**MEETING AGENDA OF THE
PLANNING COMMISSION OF THE TOWN OF FRISCO
FRISCO TOWN HALL
1 MAIN STREET
FRISCO, COLORADO 80443
JULY 16, 2026
5:00 PM**

AGENDA ITEM: Planning File No. MAJ-25-0002: A final site plan review of a proposed mixed-use development consisting of six (6) residential units and two (2) commercial units

SIXTH DEGREE TOWNHOMES
121 EAST MAIN STREET, FRISCO COLORADO 80443
(LOTS 1 & 2, BLOCK 2, KING SOLOMON ADDITION AND THE WEST 1/2 OF VACATED 2ND AVENUE)

DRAWING: C:\Users\Tom\My Documents\Projects\2021\21112-Lug Curb\Map\21112-2112-2112.dwg

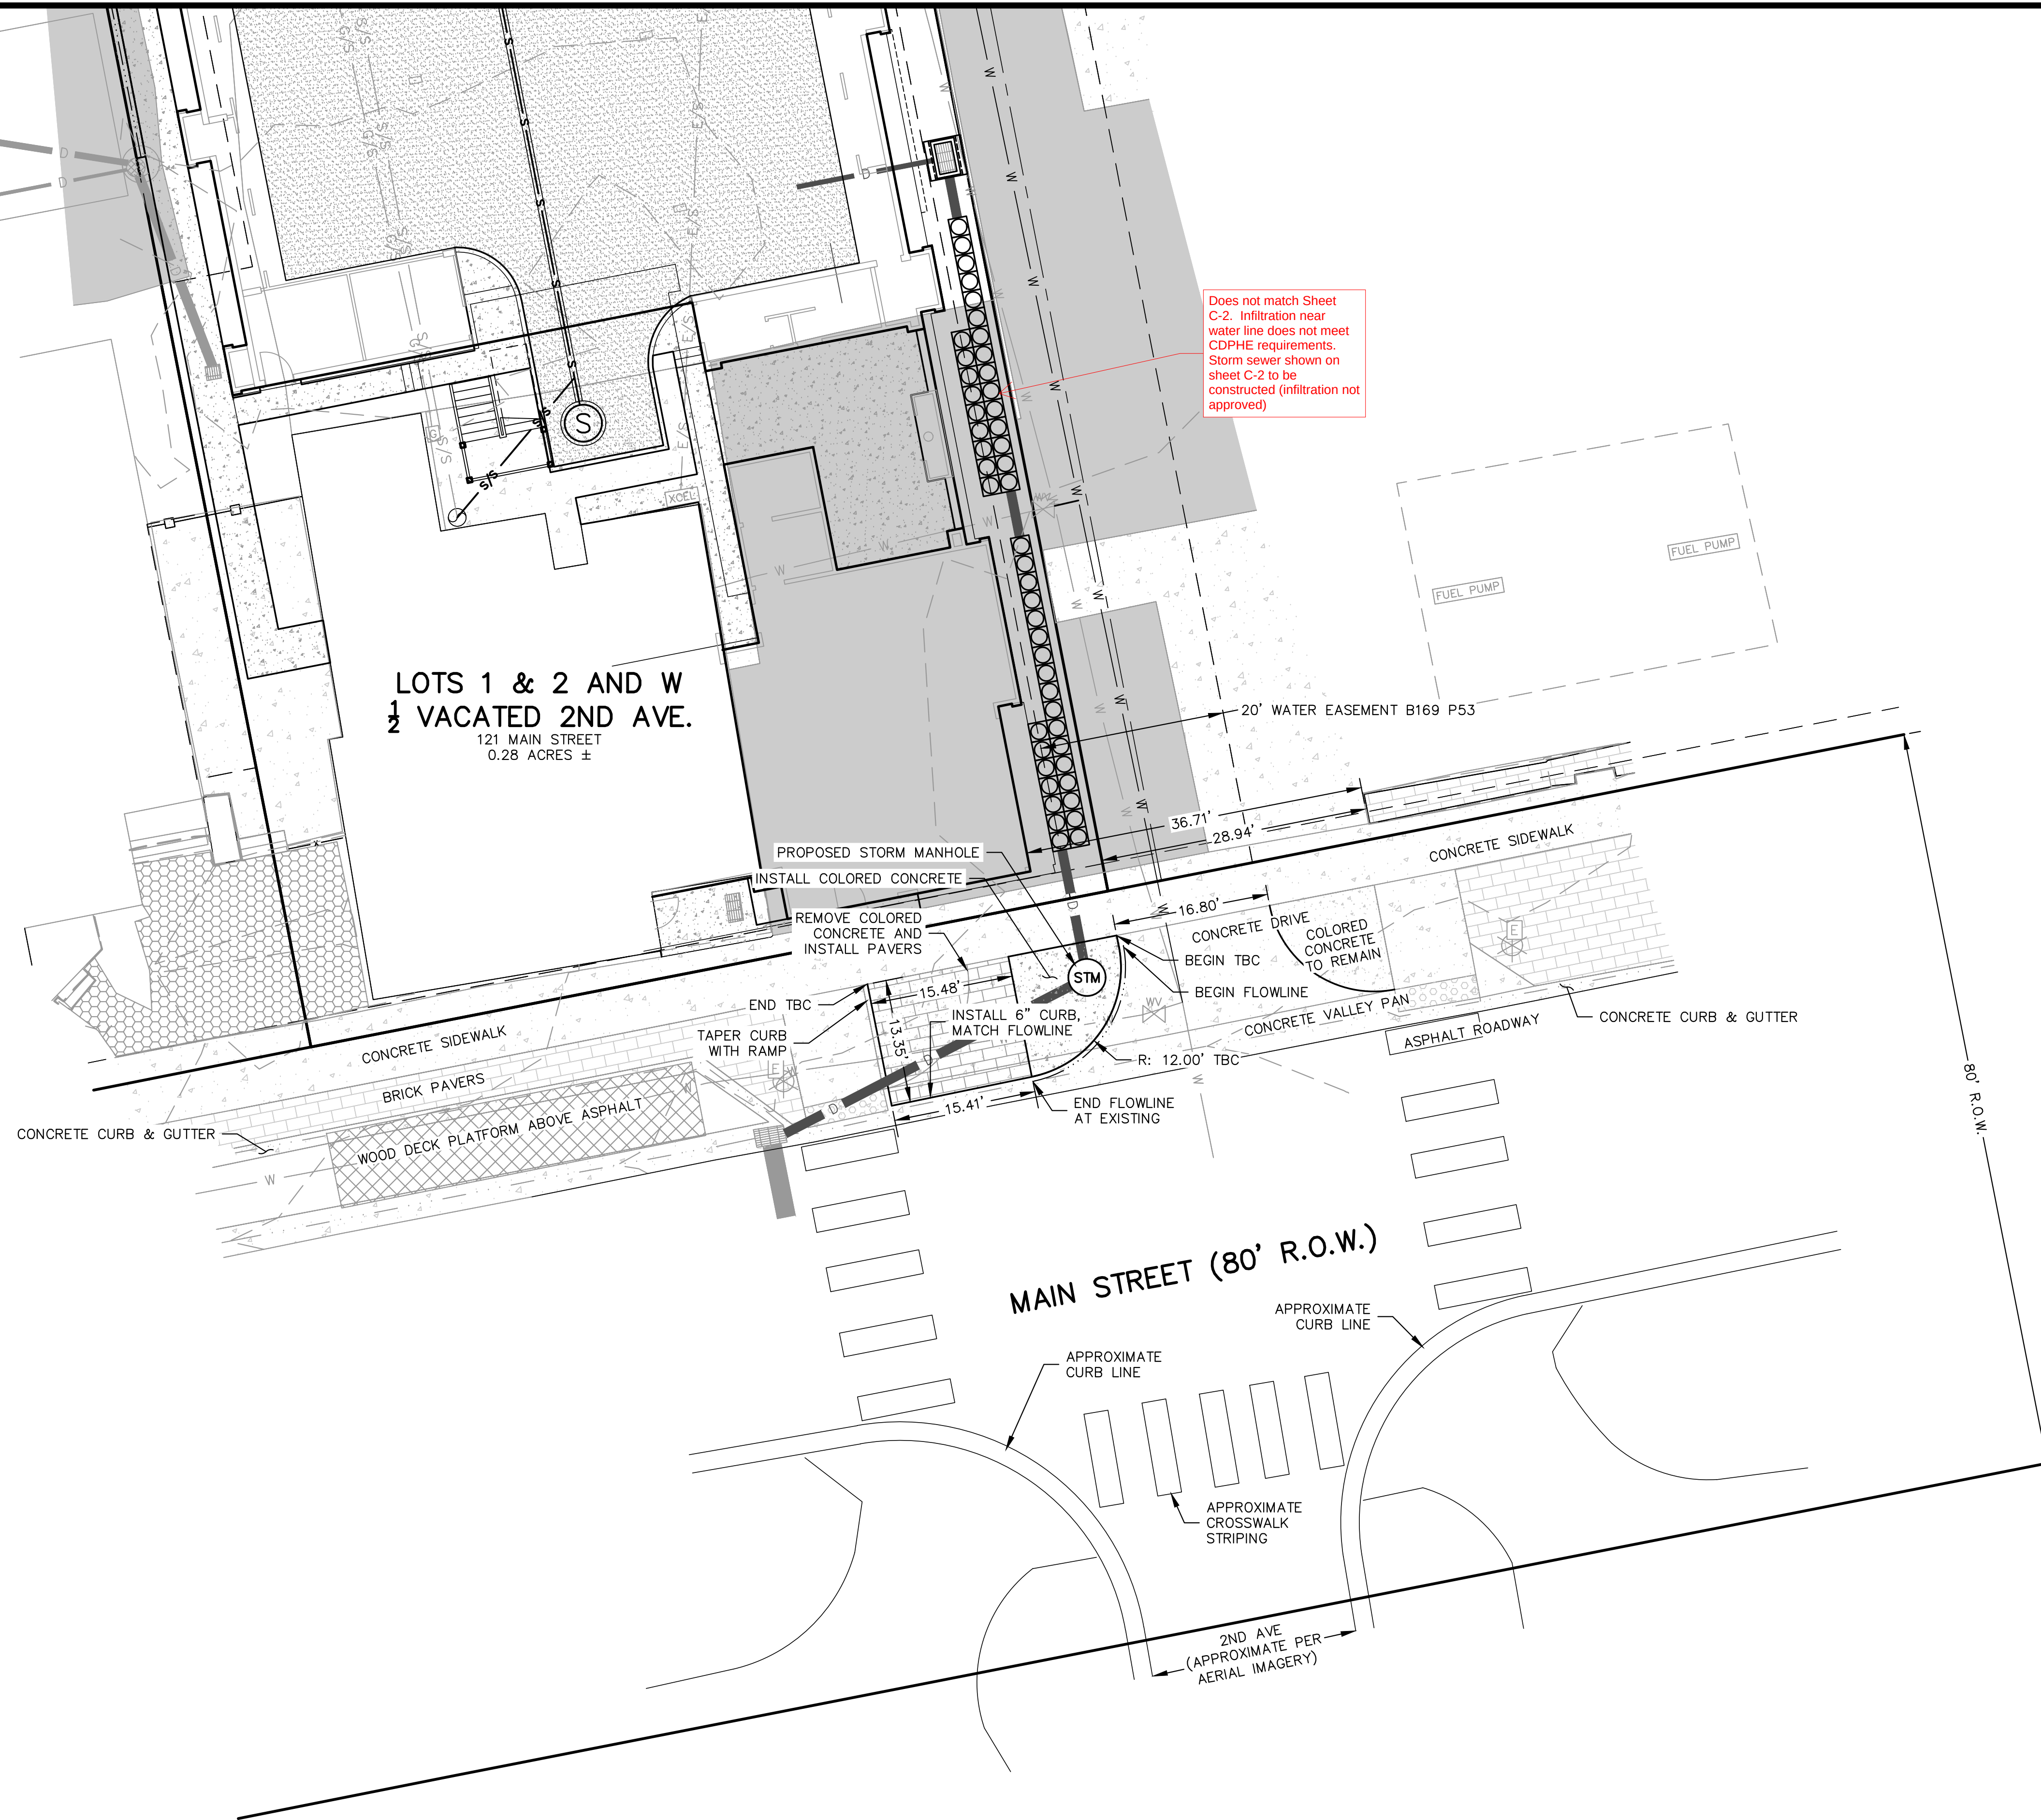
Does not match Sheet C-2. Infiltration near water line does not meet CDPHE requirements. Storm sewer shown on sheet C-2 to be constructed (infiltration not approved)
